ST/SG/AC.10/C.3/2001/48
13 September 2001

**COMMITTEE OF EXPERTS ON THE TRANSPORT OF
DANGEROUS GOODS AND ON THE GLOBALLY
HARMONIZED SYSTEM OF CLASSIFICATION
AND LABELLING OF CHEMICALS**

ADDITIONAL PROVISIONS FOR THE TRANSPORT OF GASES

Proposed provisions for refrigerated liquefied gases

The following is an example of the markings applied to a gas cylinder.

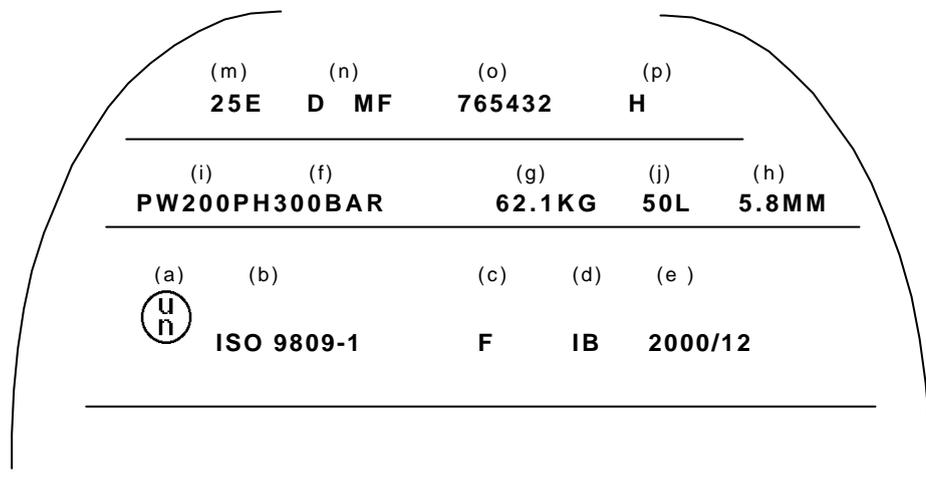
6.2.2.6.4 The above marks shall be placed in three groups ~~as shown in the example below.~~

- Manufacturing marks shall be the top grouping and shall appear consecutively in the sequence given in 6.2.2.6.3.
- The middle grouping shall include the test pressure (f) which shall be immediately preceded by the working pressure (i) when the latter is required.
- Certification marks shall be the bottom grouping and shall appear in the sequence given in 6.2.2.6.1.
